Staff Report – Planning & Zoning Item

Date: June 20, 2017
Case No.: P-17-07
Request: Replat
Applicant: Better Belton Foundation/
Belton Engineering

P-17-07 Hold a public hearing and consider a replat for Burnet South Addition, Phase I, a 0.424 acre tract of land, located on the east side of South Burnet Street, generally south of Avenue A and north of Avenue C.

RE: Project: Burnet South Addition Phase I

Name of proposed subdivision: HEART OF TEXAS

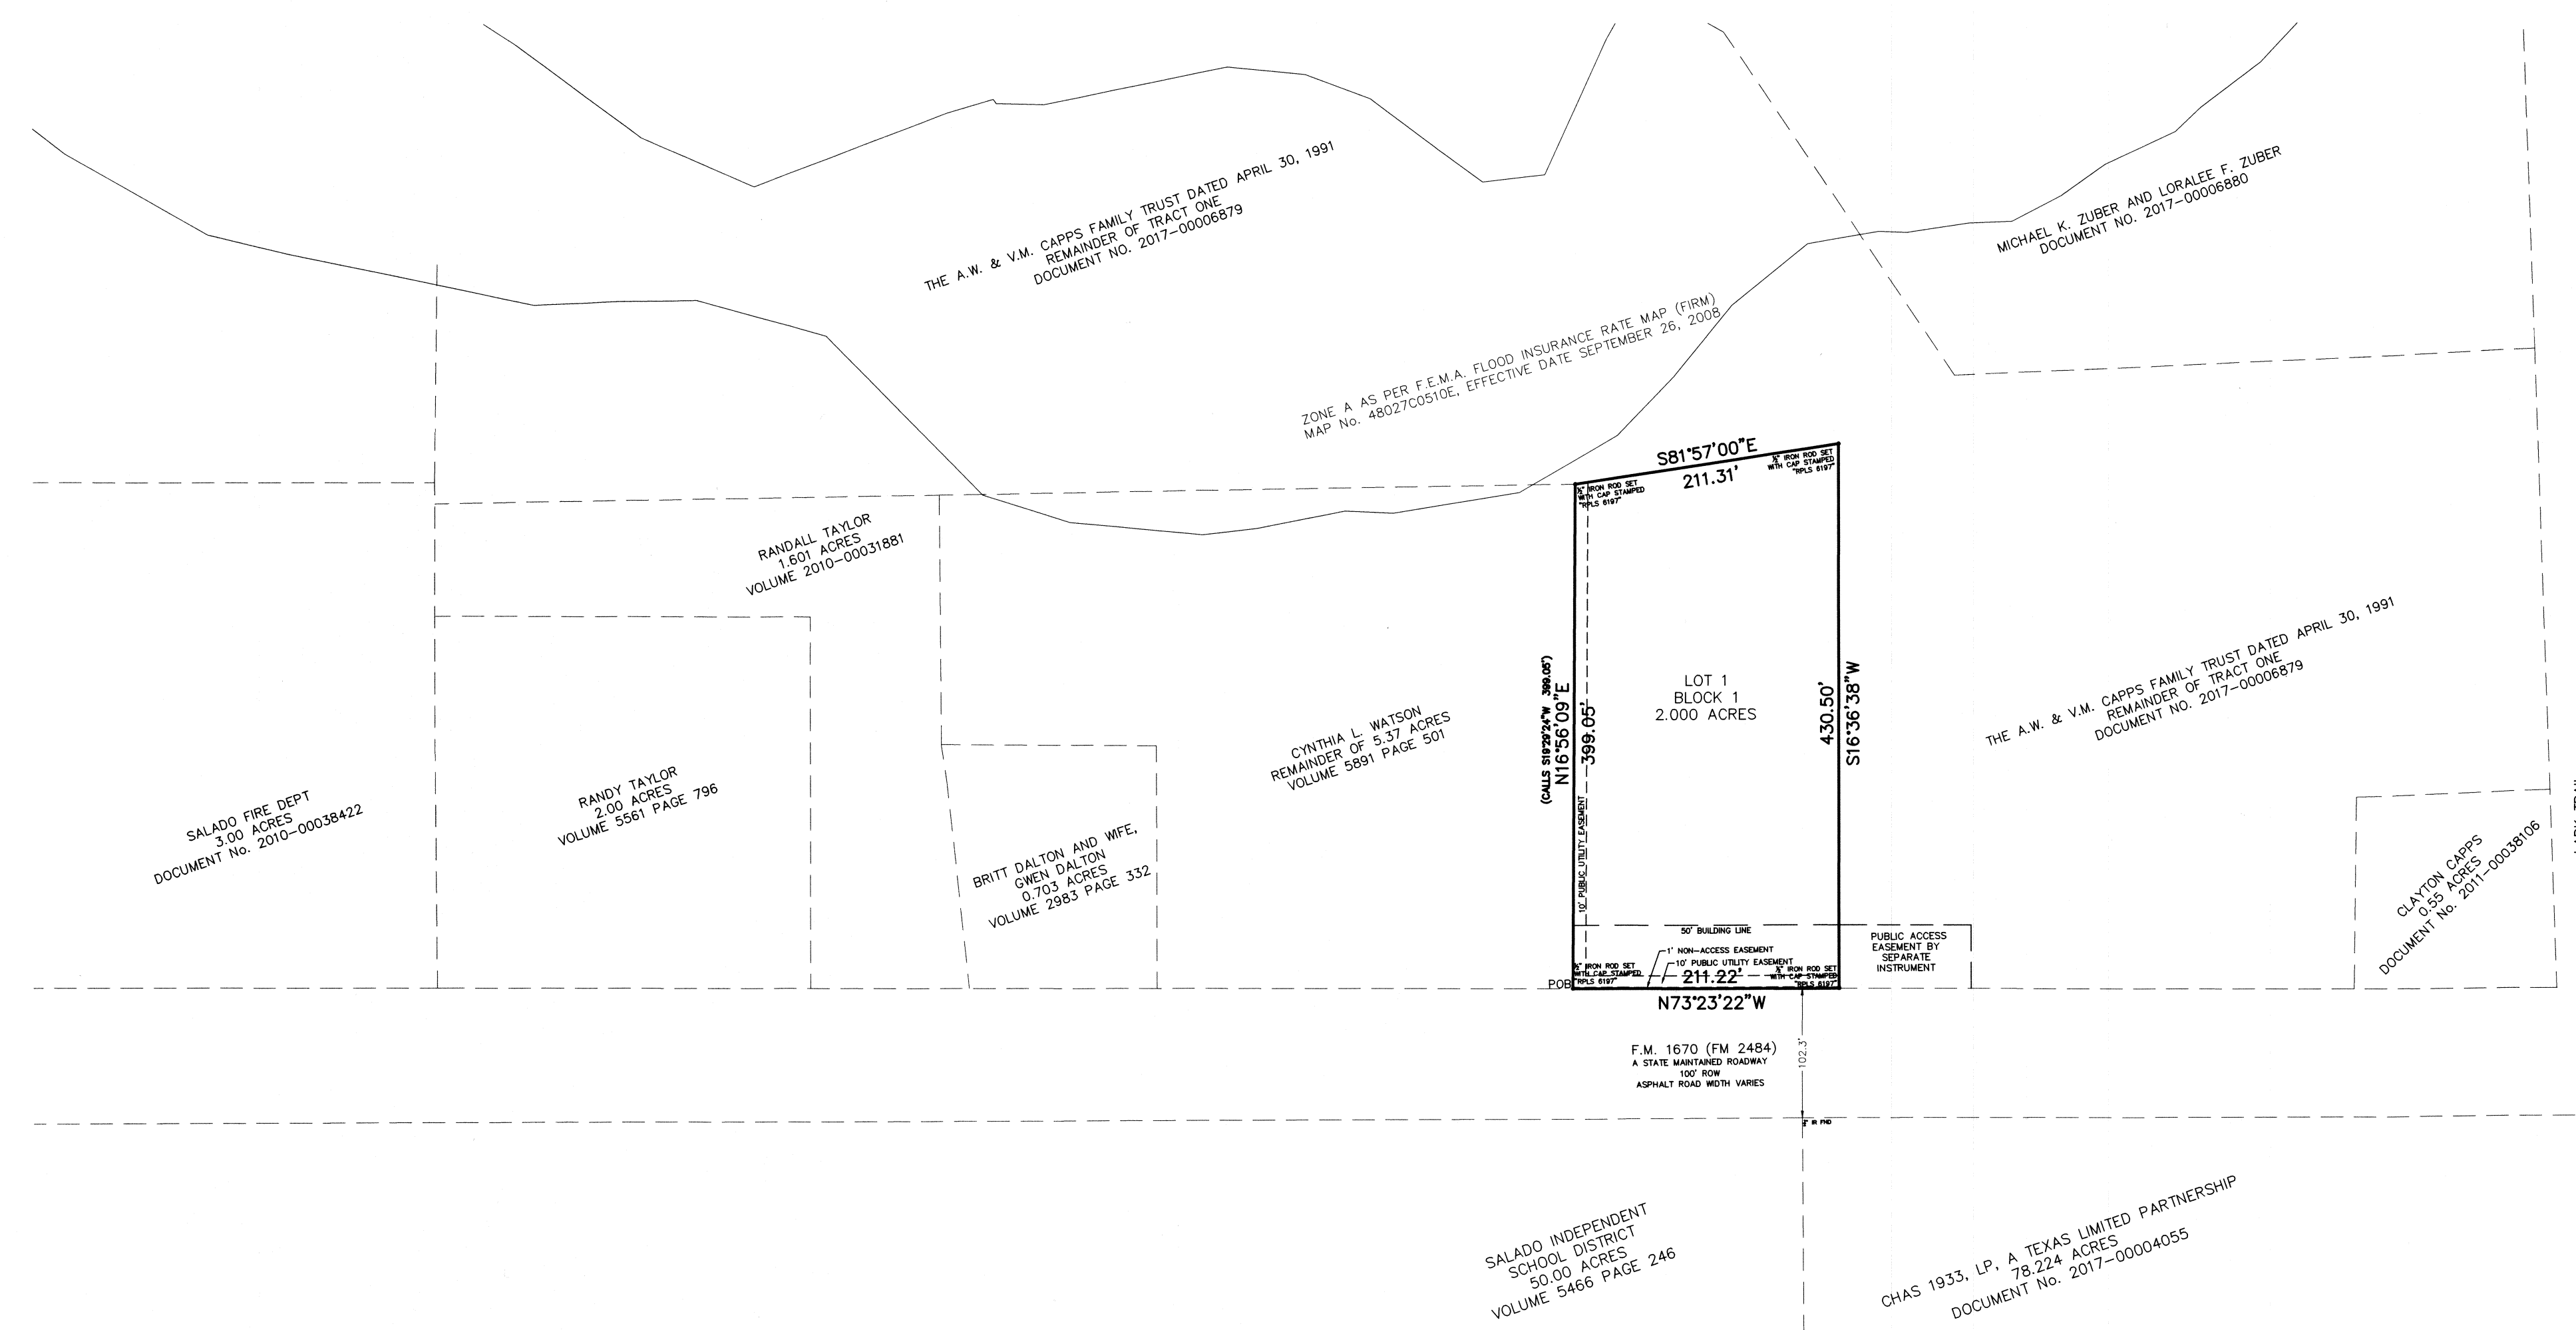
- a.i.1. Please include a 10' PUE on the portion of this lot directly adjacent to FM 1670 ROW. **Provided 10' PUE adjacent to FM 1670.**
2. We have received the transmittal letters for the utility providers; however, none of the letters were sent in someone's attention. Please re-send the proposed plat in the attention as shown on the City's utility provider form and provide us with a copy of the transmittal letter. **Responses from utility providers provided or plat resent with copy of transmittal letter provided.**

4. FM 1670 is identified as a minor collector on the Belton Thoroughfare Plan, so a 6-foot wide sidewalk is required the length of the property adjacent to FM 1670. We have received a variance request to not construct a sidewalk at this location. We recommend the applicant pay a fee-in-lieu of sidewalk construction. To determine the fee-in-lieu of sidewalk construction, please submit a cost estimate to construct sidewalks at this location for staff review. **Requesting variance not to build sidewalk or pay fee-in-lieu of sidewalk construction. Cost estimated for sidewalk provided.**

5. What is the need for the 10' utility easement along the western property line? **Existing power poles on property that serve adjacent property.**
6. Are there any existing deed restrictions associated with this property? If so, please provide a copy in the next submittal. **No deed restrictions.**

1. Verify hydrant flow and residual pressure meets the City's requirements. **Waiting on response from Salado Volunteer Fire Department. Salado Water Supply did not have the information.**
2. The site will likely be developed, which will increase impervious area, and hence increase runoff from pre-development flows. A drainage analysis and any infrastructure required to limit runoff from the site is required to be submitted to the City of Belton for review and approval prior to any development. Please also include this as a note on the plat. **Note added to plat.**
3. Please provide the approved driveway permit from TxDOT at this time. **Driveway Permit**

4. Please modify the C-values by storm event. **Done**
5. Except for the south and west drainage boundaries, the boundaries appear to reflect the property boundaries rather than the drainage boundaries (based on the contours). Unless a berm or channel is proposed to divert runoff on the north and east boundaries, this drainage area depiction is not a true reflection of the existing and proposed drainage patterns. Areas to the south and west drain onto the site. The site drains to the east and north. There is currently no site plan and no berms or channels proposed. There is a drainage boundary area around the site so pre and post development calculations can be compared. Since there is no site plan or grading plan the pre and post development calculations are the same and no detention calculations are required at this time.

1. Please identify the proposed fire hydrant location on the utility layout sheet. It is stated on this sheet, but the location is not clearly identified.
2. Please include a note on the plat that states the following: The property owner shall contact the City of Belton Fire Marshal to complete an inspection when the fire hydrant is installed.

will be approved by TXDOT when site plan is submitted to TXDOT. No site plan currently exists. Billy Tweedle with TXDOT has requested the centerline of the future driveway be 300' from edge of existing drive at Accents of Salado and only one driveway will be approved.
